AMENDMENT NO. 4

DATE: May 19, 2014

RE: VA Medical Center
5000 West National Avenue
Milwaukee, WI 53295

VA No. 695-11-127

B1
A850

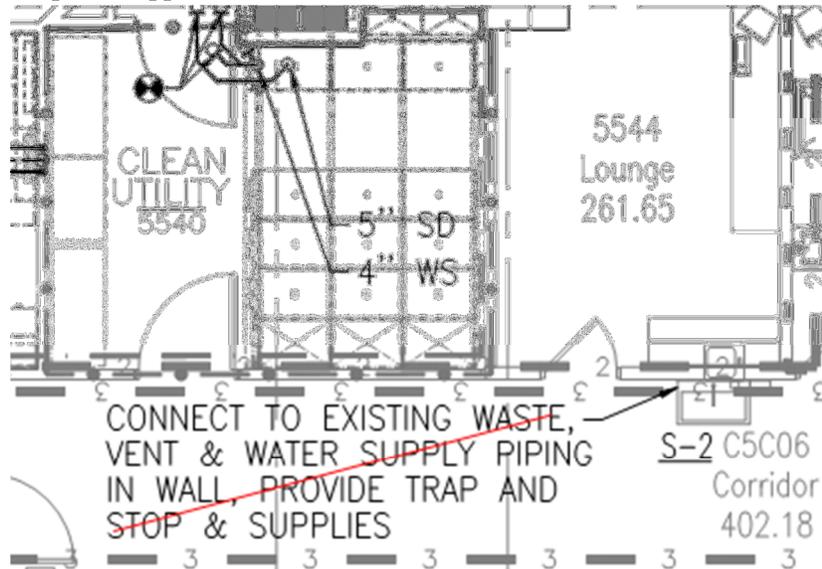
5. **Sheet A850**, detail B1: relocate WR to under counter.

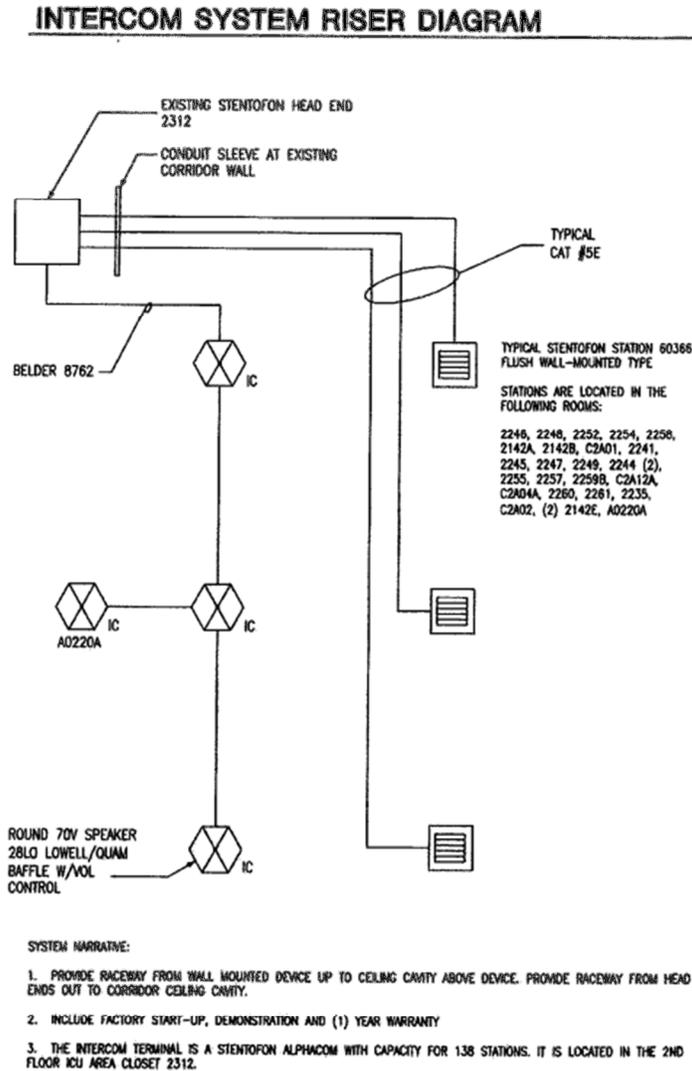
16. On drawing E401, detail #3, the Treatment Room Aiphone intercom component is not identified. What component(s) does the LEF-3 Master station in the Control Room communicate with?

Answer: Master station in Control Room shall communicate with Loud Speaker in Treatment Room. Refer to Siemens site specific drawings for additional information on intercom system.

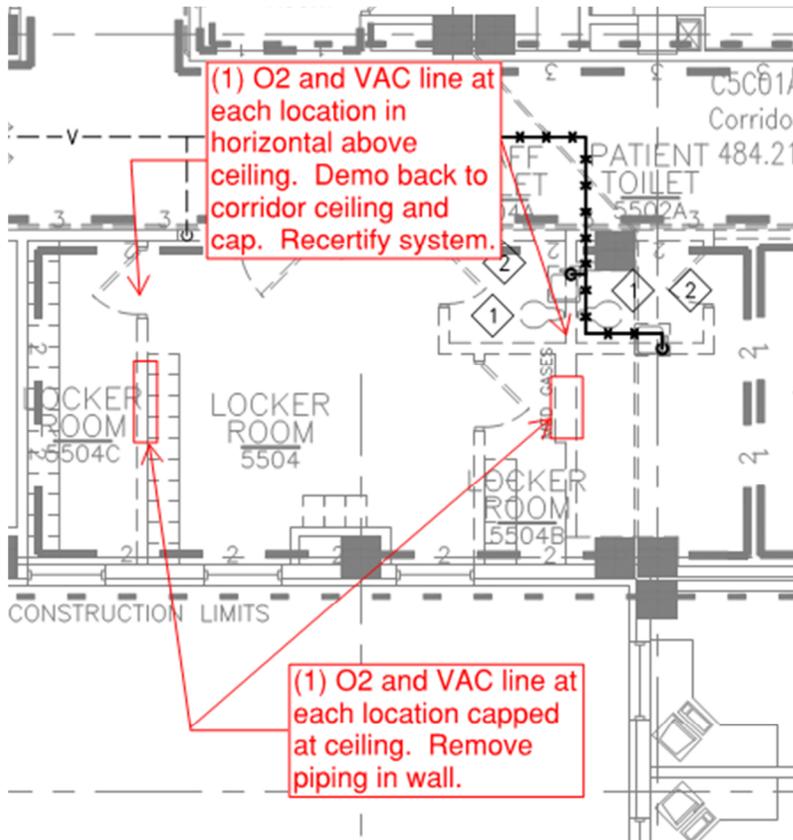
18. What is the Stentofon model number for the new Intercom referenced in question #2? Can you provide wiring/riser details?

Answer: See detail below for riser diagram.
